## ANSWERS TO SELECTED QUESTIONS RECEIVED FINAL POSTING BEFORE RFP DEADLINE

Please review the following answers carefully as some answers have been revised since they were first posted. Revised and new answers are marked as such.

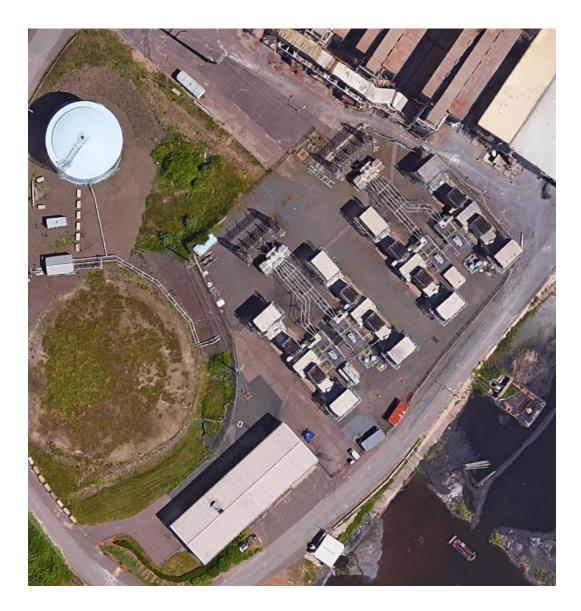
- 97. **NEW 3.1.16.** Can you confirm that the attached picture shows the jet peaking turbine facility?

Answer: Yes.
